CITY OF RIVERSIDE PLANNING DEPARTMENT

Tract Map, Rezoning and Planned Development

PLANNING COMMISSION HEARING DATE: AUGUST 19, 2004

PLANNING CASE P03-1451: Proposed Tract Map 31930 by Gabel, Cook and Becklund, on behalf of Jim Guthrie, to subdivide approximately 86.31 vacant acres into 29 residential and 5 open space lots, located southerly of terminus of Cresthaven Drive and northerly of Alessandro Arroyo in the RC - Residential Conservation and O - Official Zones.

EXHIBIT D – Proposed Zoning

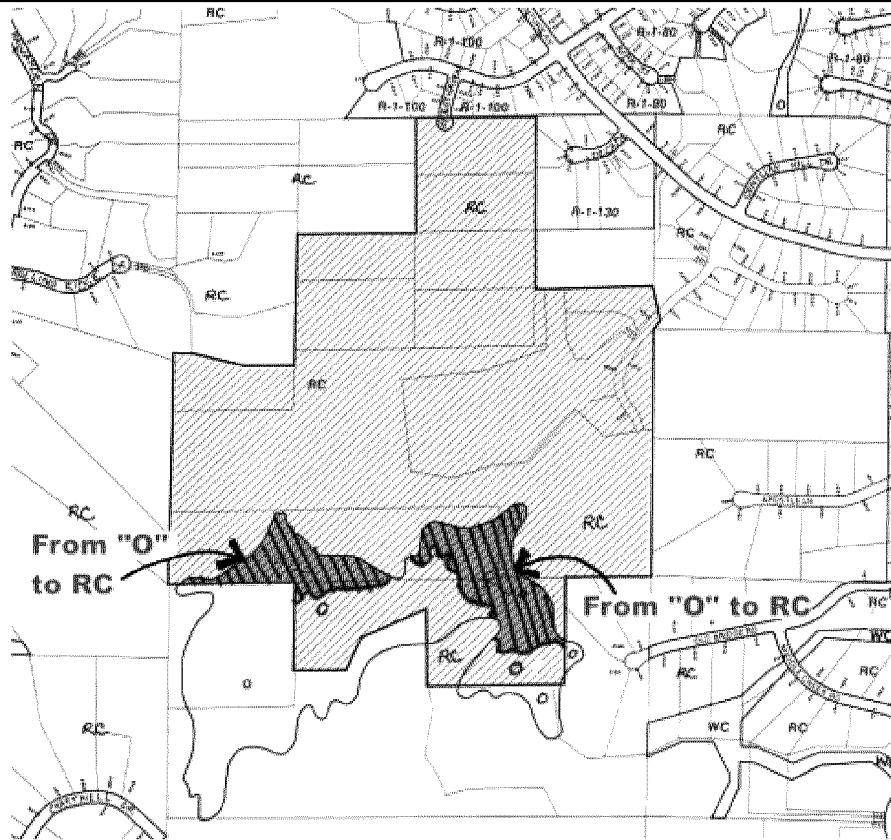
The project is consistent with the General Plan land use designations of RHS — Hillside Residential and NOS — Natural Resources Open Space. Except for approximately 7 acres generally located along the southern most portions of the project area, the property is zoned RC – Residential Conservation. Zoning Case RZ-006-912 was previously approved in conjunction with the original map and PRD (TM 23027 and PD-001-912) to rezone the southernmost 7-acres of the project area from the O — Official Zone to the RC — Residential Conservation Zone. Instead of filing a time extension for multiple years, the applicant is requesting a new rezoning application. This rezoning request will be in compliance with the previously approved PRD and Tract Maps 23027 and 28728. The site is surrounded by RC Zoned property and staff has no objection to the proposed rezoning request in order to comply with the original PRD for this property.

A portion of the area to be rezoned encompasses currently owned by the Riverside County Flood Control District, in which final approval of the County will be required in order to finalize the rezoning and map. Overall, 17.45-acres of the subject property is still owned by the Riverside County Flood Control District, in which the applicant plans to purchase this property. The applicant and County have been involved in on-going negotiations for the sale of this property. If the applicant is unable to acquire this property, the applicant will be required to revise the map to eliminate approximately 6 lots due to a loss of acreage in developable area, resulting in a maximum of 80 lots for the entire PRD.
